Re: Initial Submission Review – Metro Center Parcel A Infrastructure Site Plan and Plat
Application Number: **DA-1489-25**
Case Numbers: **2022 6034 00; 2022 3054 00**

First Submission Review

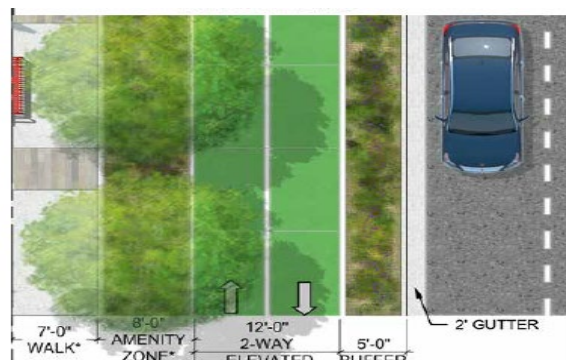
- 2A. No changes are needed for the introduction letter.
- 2B. The title for the application shall read Metro Center Infrastructure Site Plan.
- 2C. Enlarge the Vicinity Map as per the manual; the vicinity map should be 3 inches by 4 at a scale that the map includes the closes arterial street intersection and all surrounding local roads. The perimeter roads need to be labeled.
- 2D. All site plans shall be drawn at a uniform engineering scale of 1 inch = 40 feet or smaller.
- 2E. Update the sheet index to have just the numbering and sheet title.
- 2F. You do not need an existing ownership map – please delete it. Add the plat name, reception number, and lots and blocks to the site plan. There is no need for the existing ownership map.
- 2G. Include abutting zone districts, typical of all set plan sheets.
- 2H. The proposed storm line in the legend does not match the weight on the sheet.
